Access Compliance Report

Public Rights-of-Way

(Curb Ramps)

Intersection ID: 23772	Main Street: KNIGHTSWOOD_DR	Cross Street: OLD_FORGE_DR	Location: SE
ADA ID: 1ADFE588DFF6	Ramp Type: PerpDiag	Initial Pass/Fail: Fail	Overall Compliance: No
Codes/Mitigation Info/Possible Solution		Field Measurements/Component Compliance	
Severity Score: 22.5

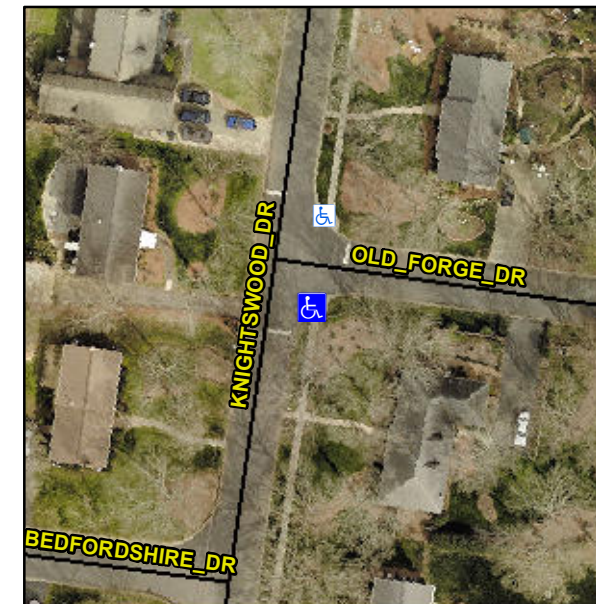
Not Found, R304.5.1, R304.2.2, R304.5.3

Compliance	Description	Data	Compliance	Description	Data
N/A	Ramp Length (in)	73.0	No	Ramp Slope (%)	8.7
No	Ramp Width (in)	47.5	No	Ramp XSlope (%)	4.2
N/A	Flare Type LT	N/A	N/A	Flare Type RT	N/A
N/A	Flare Slope LT (%)	N/A	N/A	Flare Slope RT (%)	N/A
N/A	Flare Traversable LT?	N/A	N/A	Flare Traversable RT?	N/A
N/A	Landing Length (in)	N/A	N/A	DWS Provided?	N/A
N/A	Landing Width (in)	N/A	N/A	DWS Contrast?	N/A
N/A	Landing Slope (%)	N/A	N/A	DWS Length (in)	N/A
N/A	Landing X Slope (%)	N/A	N/A	DWS Full Width?	N/A
N/A	Landing Curb? (Y/N)	N/A	N/A	DWS Offset (in)	N/A
N/A	Shared Landing?	N/A			
N/A	Gutter Ponding?	N/A	N/A	Gutter Slope (%)	N/A
N/A	Gutter Lip Ht (in)	N/A	N/A	Gutter X Slope (%)	N/A
N/A	Painted X Walk1?	No	N/A	Painted X Walk2?	No
	X Walk 1 Direction	To NE		X Walk 2 Direction	To W
N/A	X Walk 1 Width (in)	N/A	N/A	X Walk 2 Width (in)	N/A
	X Walk 1 Slope (%)	0.6		X Walk 2 Slope (%)	3.4
	X Walk 1 X Slope (%)	1.6		X Walk 2 X Slope (%)	2.1

Remove & Replace Curb Ramp With Two New Directional Ramps or Equivalent.
